DE17.59 Exhibition outcomes - Planning Proposal LP406 and DCP Chapter N16 - Falls Creek / Woollamia Deferred Areas

HPERM Ref: D17/187131

To detail and consider feedback received as a result of the exhibition of the Falls Creek / Woollamia Deferred Areas Planning Proposal (PP) LP406 and supporting draft Development Control Plan (DCP) Chapter N16.

4. Post exhibition lot size map - Woollamia Road - LP406 U

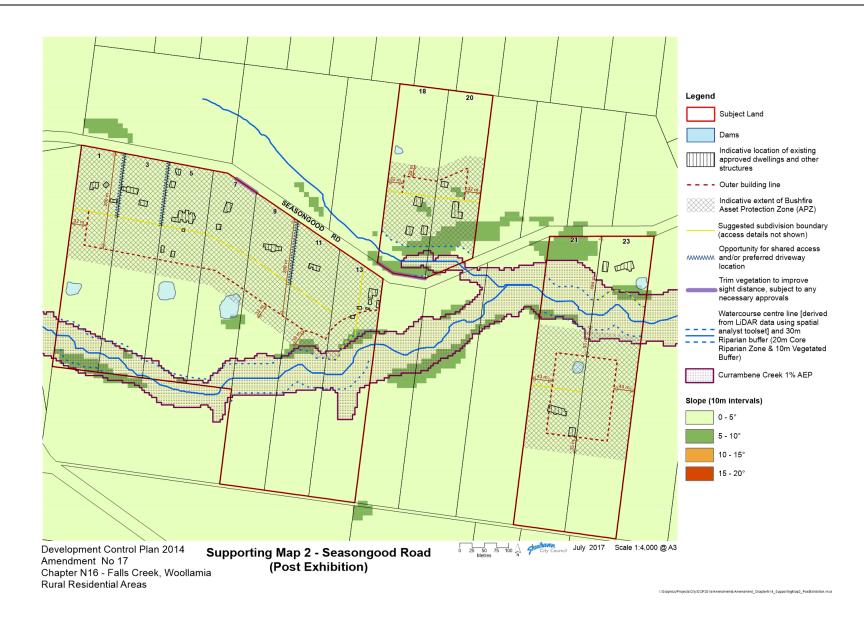
Request that Council amend the minimum lot size map to align with their proposed revised minimum lot size map based on:

- 2 ha at the front of the site;
- 1 ha in the middle of the site; and
- 3 ha at the rear of the site.

Overall requested change is not supported: 3 ha is too small for the rear lot as it would result in development overlapping into the riparian buffer.

The exhibited lot size map has however been amended slightly to ensure that the boundary between the middle and rear lot is well to the north of the dam. The revised lot size map is attached (Attachment 4)

The 'kink' in the Lot Size Map between the 2ha and 1ha areas is to ensure that the large dam located on the site is retained within the front lot. This dam forms part of the critical infrastructure relating to the operation of the miniature horse stud.	
The proposed building areas are within the Council investigation area.	The curtilage of the dwellings (APZ) would overlap substantially into the riparian buffer and the building envelope (15 metres x 15 metres) would be too small in this context.
